STAFF RECOMMENDATION
1704 Russell Street
November 20, 2019

Application: Demolition—Partial; New Construction—Addition
District: Lockeland Springs-East End Neighborhood Conservation Zoning Overlay
Council District: 06
Base Zoning: R6
Map and Parcel Number: 08314012800
Applicant: Thomas Agee, Architect
Project Lead: Sean Alexander, sean.alexander@nashville.gov

<p>Description of Project: The applicant proposes to demolish an existing rear addition and to construct a new addition to an historic house.</p> <p>Recommendation Summary: Staff recommends approval of the proposed rear addition at 1704 Russell Street with condition that the window and door selections shall be approved by MHZC Staff. Meeting that condition, Staff finds that the project will meet the design guidelines for additions in the Lockeland Springs East-End Neighborhood Conservation Zoning Overlay.</p>	<p>Attachments A: Photographs B: Site Plan C: Floorplans D: Elevations</p>
--	---

FLOOR PLAN

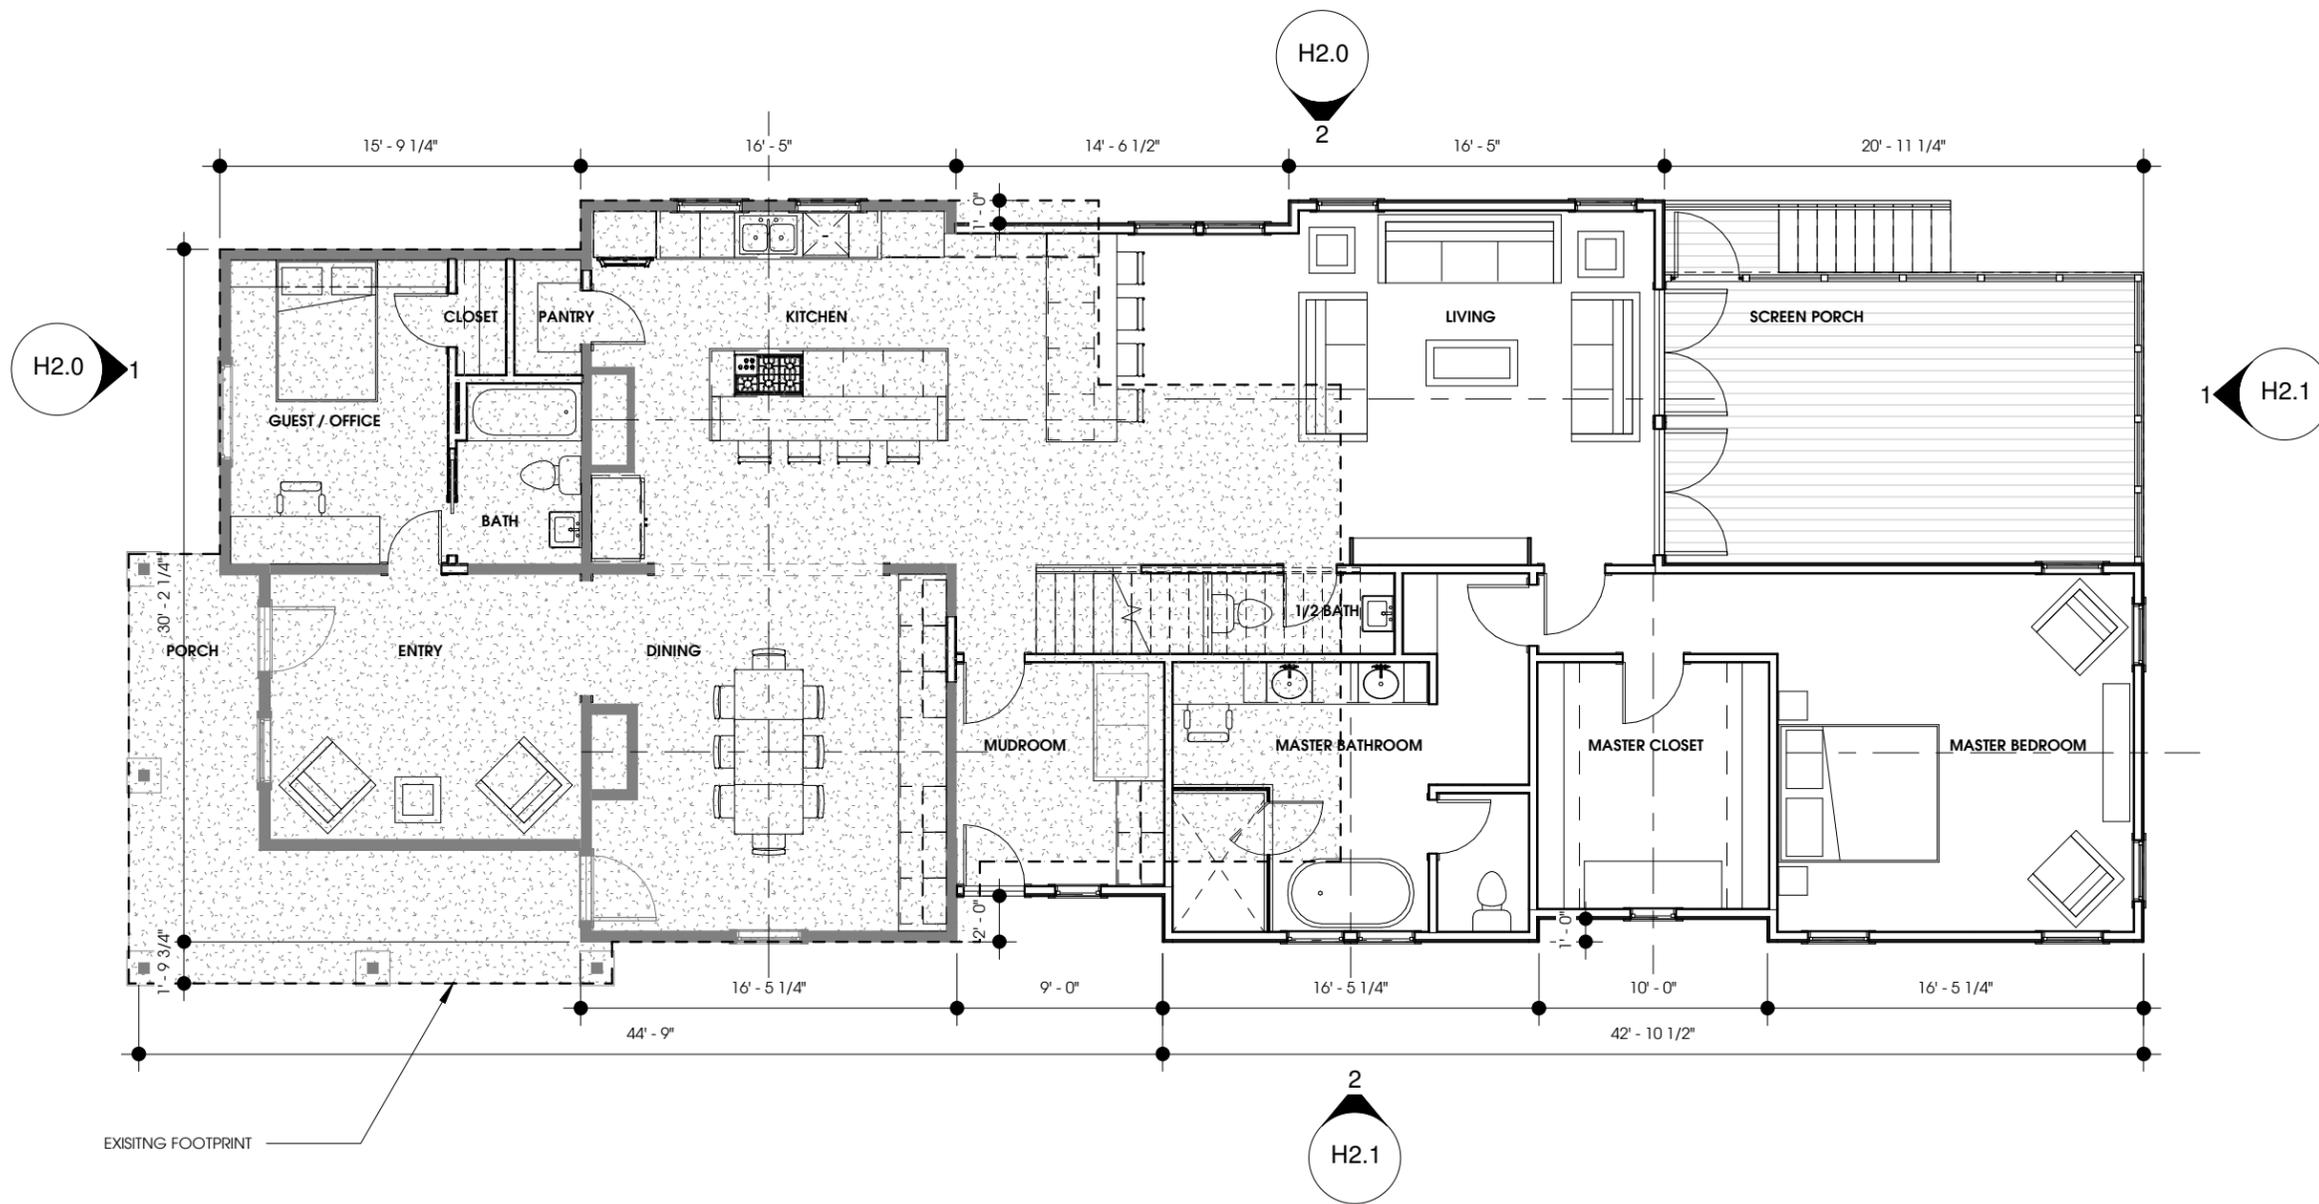
Demolition: The project involves demolishing the original rear-projecting gable, along with portions of the rear roof slope of the historic house. The sides of this gabled component are stepped in from the primary walls of the house by four feet (4') on the right side and nine feet (9') on the left. Although demolition of historic features is generally not appropriate, this component does not contribute significantly to the character of the house because it is at the rear and stepped in from the primary walls of the house and is not visible from the right-of-way.

Location & Removability: The new addition will attach to the rear of the historic house, stepped in one foot (1') from the rear-left corner of the house's primary mass and two feet (2') in from the right. As the addition extends back it steps back out to match the width of the primary building but will not go wider. The roof of the addition will tie into the rear slope of the house's original pyramidal roof, stepped down one foot (1') below the ridge.

Height & Scale: The addition will attach to the rear of the historic house, stepped in one foot (1') from the rear-left corner of the house's primary mass and two feet (2') in from the right. The addition will extend back, stepping out to match the primary building mass after a span of nine feet (9') on the right side and fourteen feet (14') on the left. The addition will be articulated further as it extends toward the rear, adding thirty-five feet (35') to the house's original fifty foot (50') depth.

ELEVATIONS

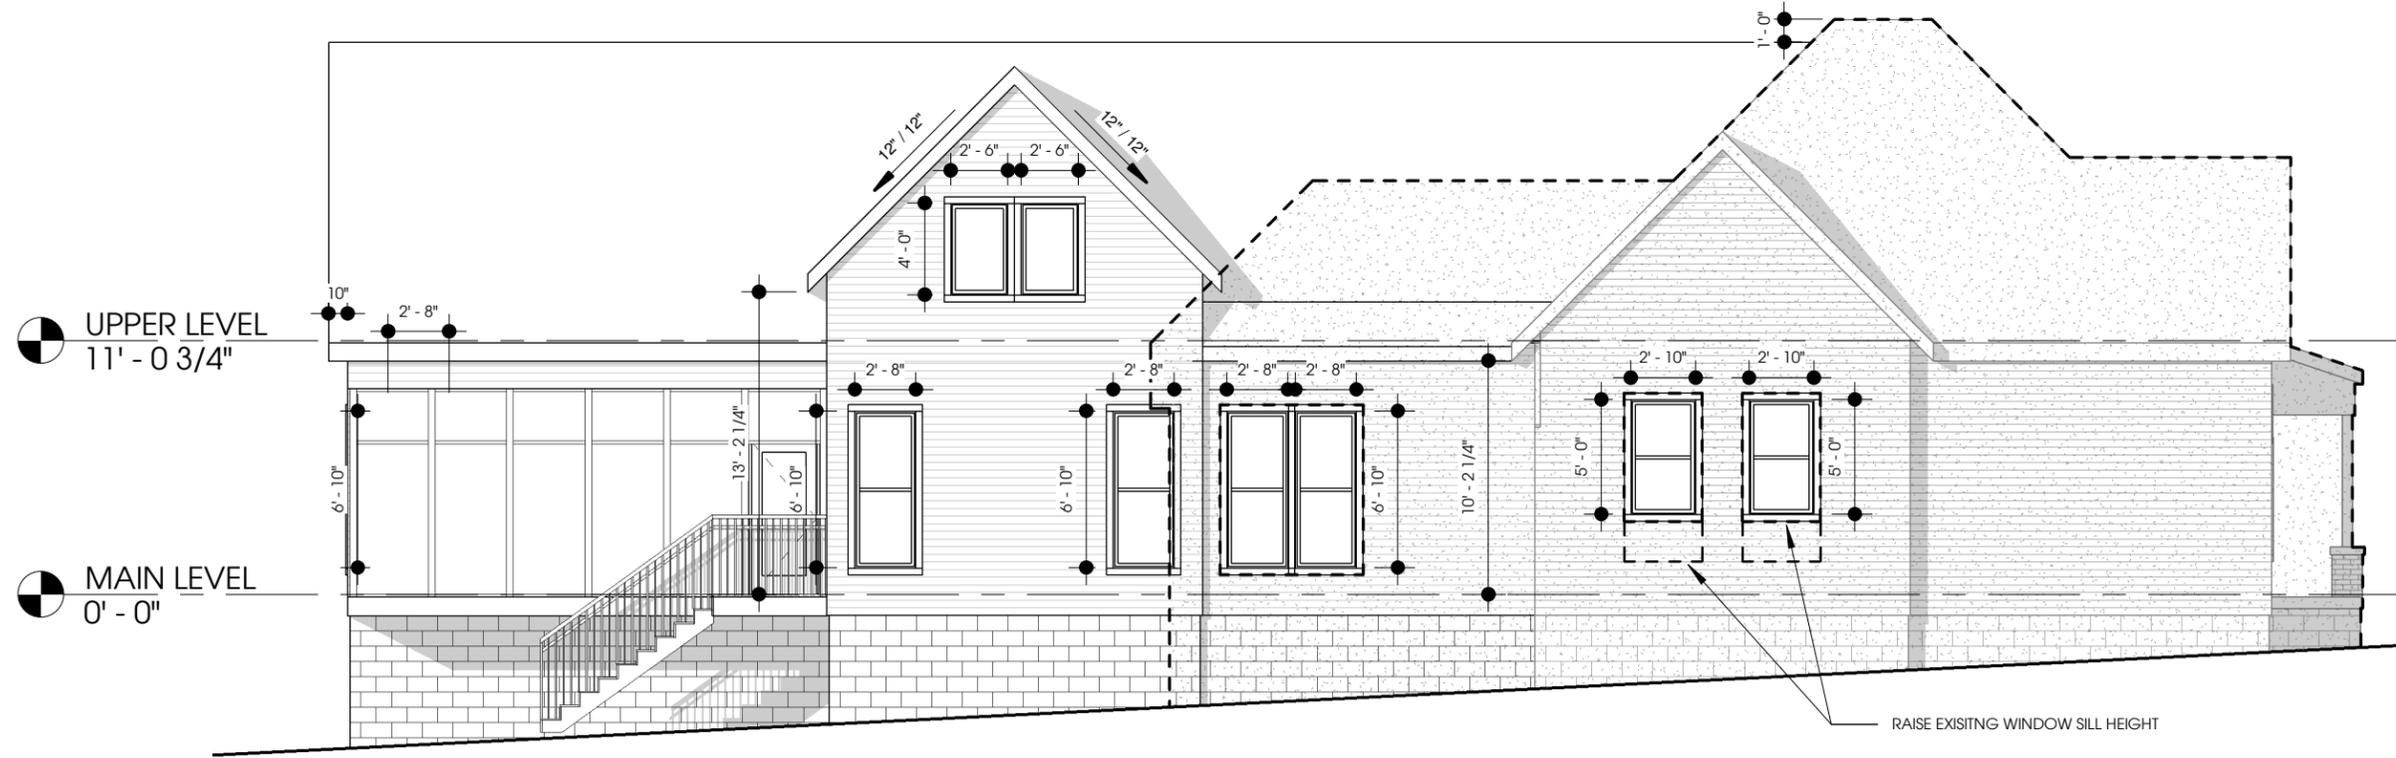
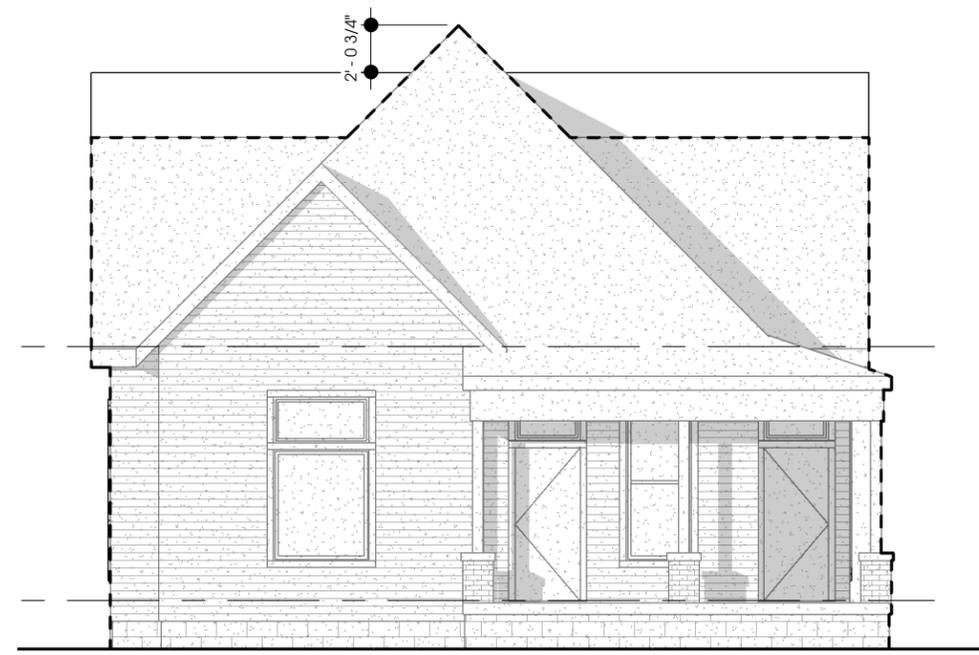
The roof of the addition will have a rear-gabled component one foot (1') shorter than the house's original roof ridge, with side-projecting gables an additional one foot (1') lower. These side gables will be two feet, nine inches (2'-9") higher than the original side gabled projections on the house, however they will be more than twenty-five feet (25') behind the original house. At this

distance and because they will be shorter and will not be wider than the original building, staff finds that the scale of these components will be compatible in the perspectives from where they could be viewed from the right-of-way. Similarly, the eave height on the new side gables will be three feet (3') higher than that of the original house but they will be largely obscured by the historic house in front.

Proportion and Rhythm of Openings: The window openings on the new addition will be vertically oriented openings, arranged in singles and pairs. The sizes and spaces between openings on the left side of the addition are consistent with the openings on the historic house. Staff finds that the window proportions and rhythms are generally compatible with the historic house and that the project will meet section II.B.7 of the design guidelines.

Staff recommends that the window selections are approved administratively to ensure that they are compatible with historic houses and meet section II.B.4 of the design guidelines.

Recommendation: Staff recommends approval of the proposed rear addition at 1704 Russell Street with condition that the window and door selections shall be approved by MHZC Staff. Meeting that condition, Staff finds that the project will meet the design guidelines for additions in the Lockeland Springs East-End Neighborhood Conservation Zoning Overlay.

ELEVATIONS

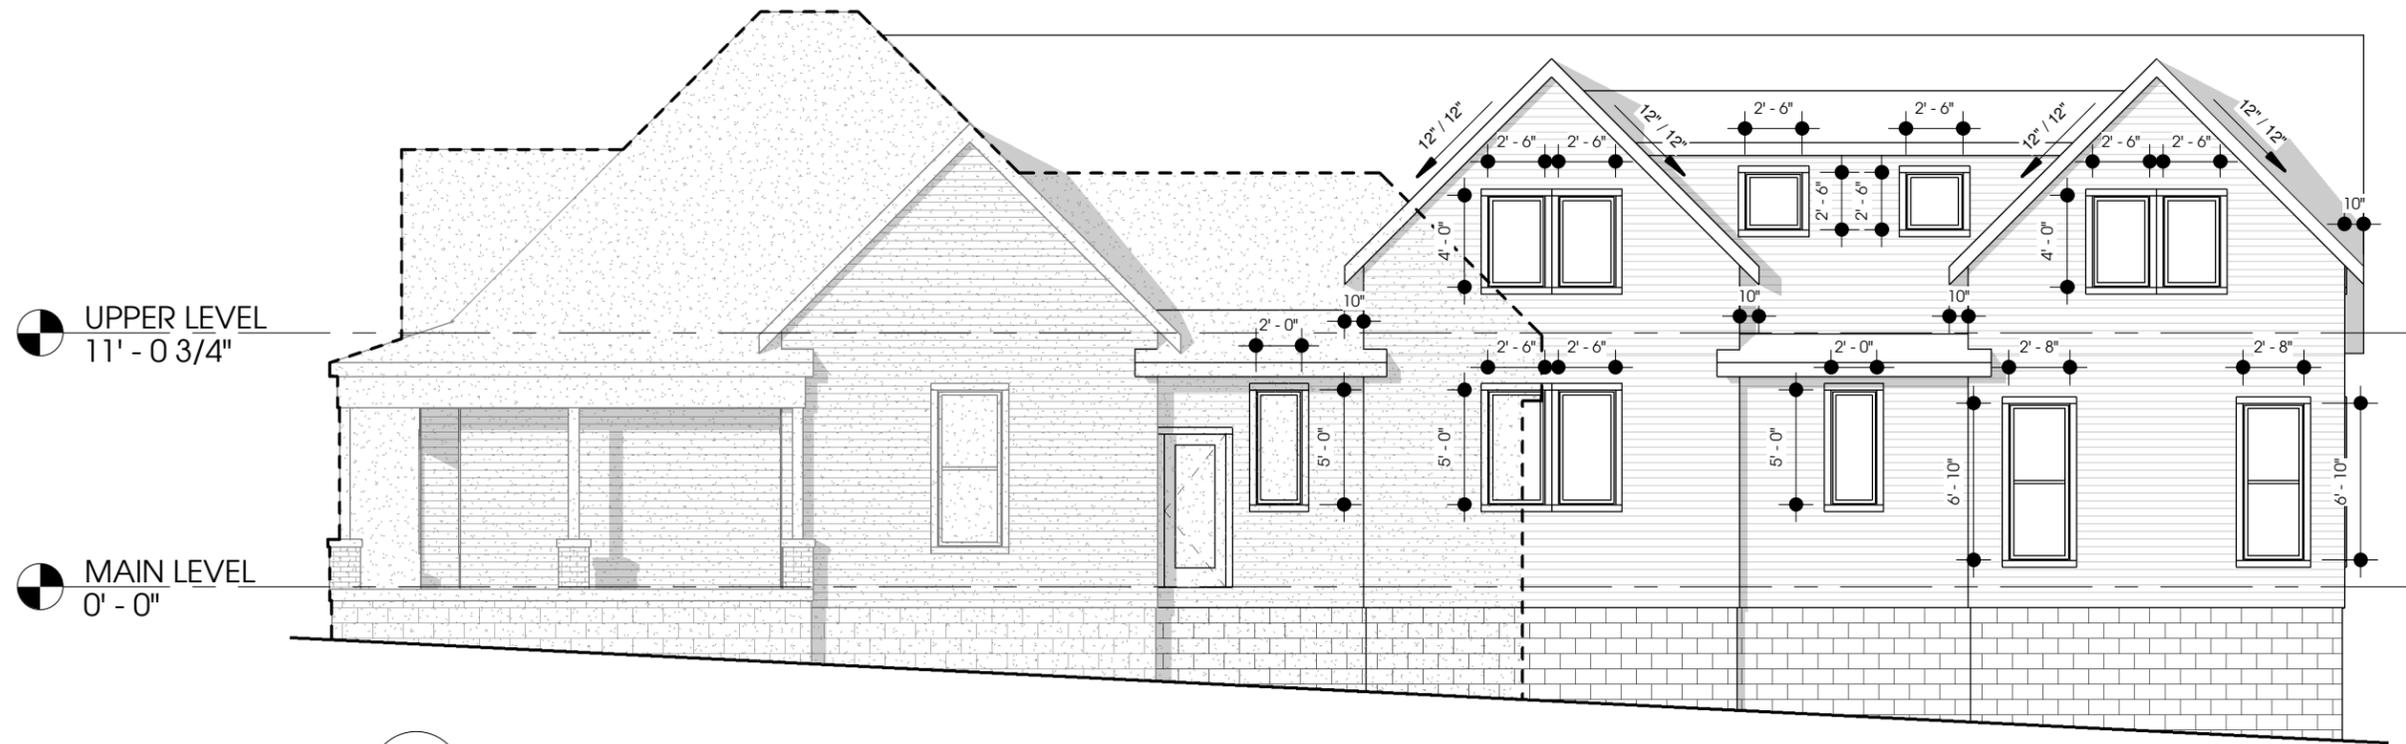
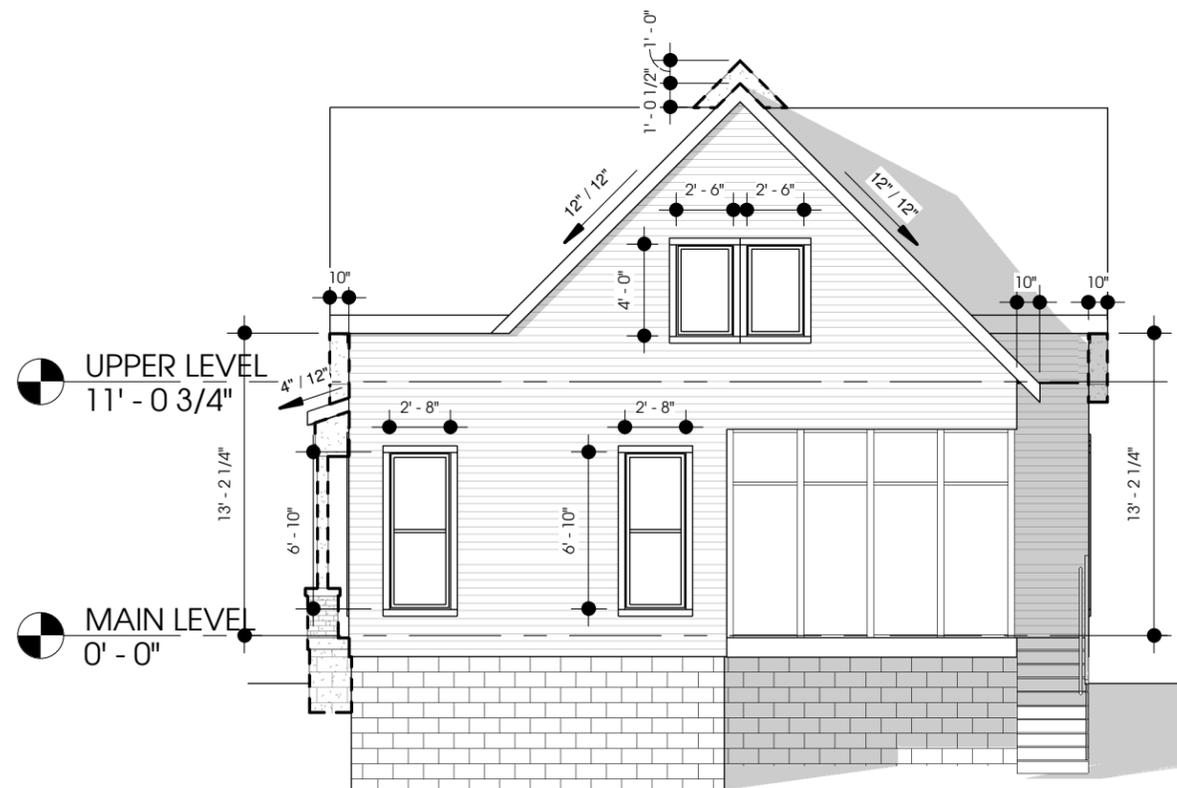
The plans show a pair of windows on the left side of the house will be shortened, but their locations will not change. Because the locations of the windows will not change and because their orientation will still be vertical, staff finds that this does not significantly alter the appearance of the building.

Roof form: The primary roof of the addition will be a rear-oriented gable with gabled projections on the sides, matching the form and pitch of the existing roof.
